File Number:	<u>CC-12-83</u>
Date Filed:	<u>5/19/83</u>
3-Month Period Ends:	<u>8/18/83</u>
6-Month Period Ends:	<u>11/18/83</u>
Staff:	<u>LTT & Staff</u>
Hearing Date/Item:	<u>11/15/83 - 5a.</u>

FINAL STAFF RECOMMENDATION ON CONSISTENCY CERTIFICATION

Applicant for federal permit: Chevron U.S.A., Inc.

Project Description: One 48-slot drilling and production platform (Hermosa) on Lease OCS P-0316; two subsea oil and gas pipelines from platform to shore; continuation of pipelines onshore to new oil and gas processing facilities at Gaviota; and an ocean outfall wastewater pipeline near Gaviota.

EXHIBIT NO. 8
APPLICATION NO. CC-12-83
Chevron U.S.A., Inc.
 California Coastal Commission

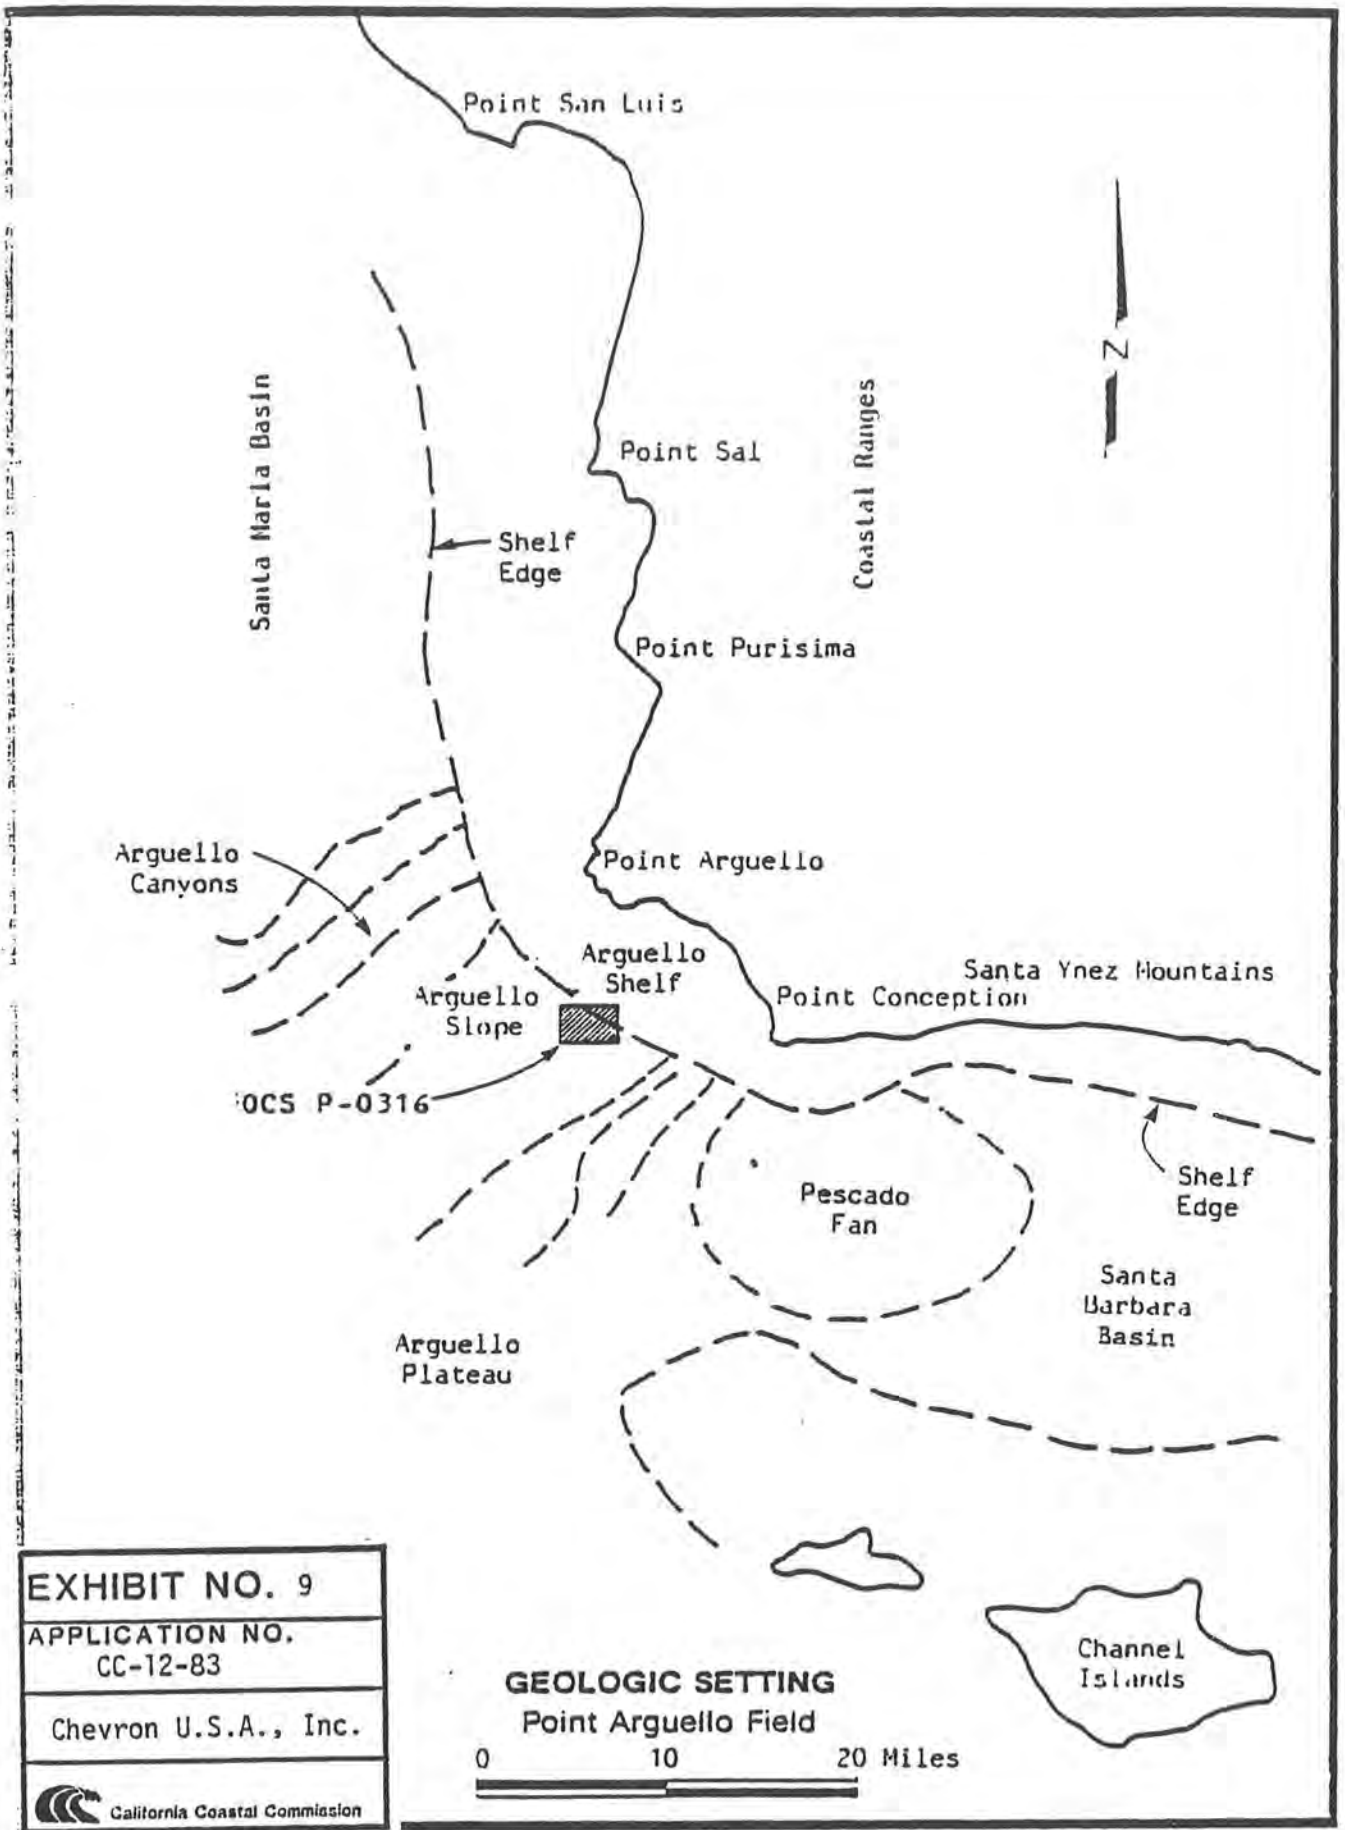
Platform Site. Chevron proposes to site Platform Hermosa on OCS P-0316, which is at least three miles north of the proposed extension of the Santa Barbara Channel Vessel Traffic Separation Scheme (VTSS). (see Exhibit 8). Although there are no platforms currently in the area, four platforms, including Hermosa, are planned for the area.
